TR3650 MANUAL TRANSMISSION—JUMPS OUT OF GEAR 2ND AND/OR 3RD—CLASH NOISE AND/OR RASPY FEEL ON GEAR ENGAGEMENT

TSB 04-15-6

2001-2003 Mustang

Figure 1 - Article 04-15-6

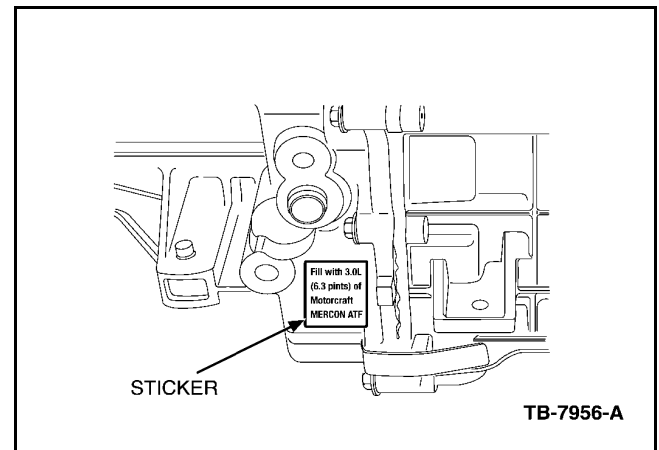
4. Clean oil from area 26 mm (1") below the transmission fill plug (Figure 1) and install the oil fill sticker included in the kit.

5. Reinstall the transmission.
6. Fill the transmission with 3.0 liters (6.3 pints) of Motorcraft Mercon ATF (XT-2-QDX). The full fill level is approximately 19 mm (0.75") below the fill hole.
